Office Action Summary

10/663,889

MCCLURE ET AL.

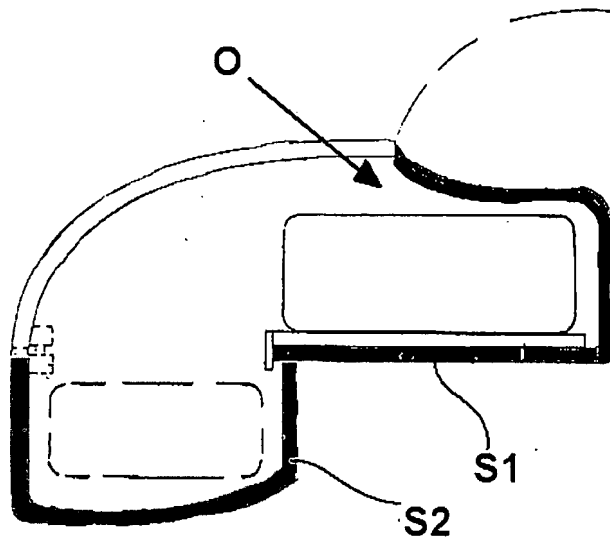
Regarding claims 1 and 11, Wilson discloses a vehicle having a support structure comprising: a first shell (S1, see figure below) attached to the vehicle, the first shell including first and second end portions and a bottom portion (13) extending at least partially between the first and second end portions, the first shell at least partially defining a storage chamber and including an opening providing access (O, see figure below) to the storage chamber, the opening being adjacent to the first end portion; a second shell (S2, see figure below) extending outwardly from the first shell; a support

member (15) adapted to support a spare tire (S), the support member being slidably positioned above the bottom portion and movable back and forth along a movement path from a first position (Figure 1) in which the support member is substantially disposed within the first shell and a second position (Figure 2) in which the support member is at least partially disposed outside the first shell and disposed at least partially inside the second shell.

Wilson fails to disclose the lower surface of the support member directly contacting the bottom of the first shell. Instead, Wilson discloses a series of rollers (33) positioned on the bottom of the first shell. The support member slides on the rollers instead of directly contacting the first shell. Wilson also fails to disclose a pair of wheels rotatably attached to the first shell, the wheels cooperating with the bottom portion of the first shell to therebetween receive side sections of the support member such that the wheels contact the side sections when the support member is at the first position for
